ALERT SERVICE BULLETIN

NAVIGATION - Attitude and Heading Reference System (AHRS) Connection modification on connector "11 ALPHA" (AHRS)

Corresponds to modifications 0722B51 and 365A084754.00

Figure 1

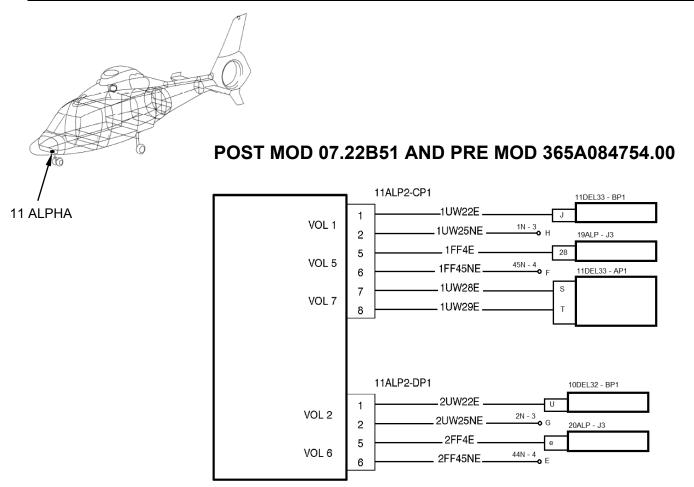
- Open the radome to access unit "11 ALPHA" (a).
- Remove the Pelican rack equipment as per AMM Task 34-70-05-062.
- 3.B.2.a. Wiring modification (corresponds to modification 0722B51) (Figure 1)

- Disconnect connector "11ALP2-DP1" (b) from unit "11 ALPHA" (a) (Detail A).
- Modify the wiring on connector "11 ALPHA" as per Figure 1.
- Perform a continuity test of the modified wiring.
- Connect connector "11ALP2-DP1" (b) to unit "11 ALPHA" (a) (Detail A).
- 3.B.2.b. Connection modification (corresponds to modification 365A084754.00) (Figure 2)

PRE MOD 07.22B51

POST MOD 07.22B51

Figure 2

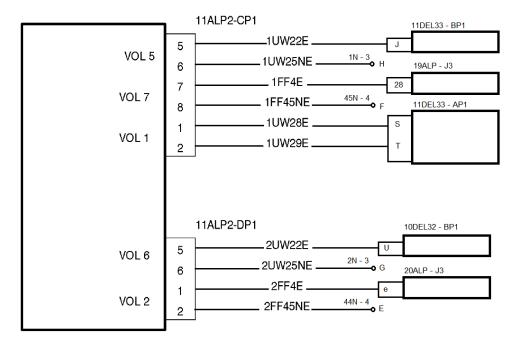
- Modify the wiring on connector "11 ALPHA" as per Figure 2.
- Perform a continuity test of the modified wiring.
- Install the Pelican rack equipment as per AMM Task 34-70-05-062.
- Close the radome.

POST MOD 07.22B51 AND POST MOD 365A084754.00
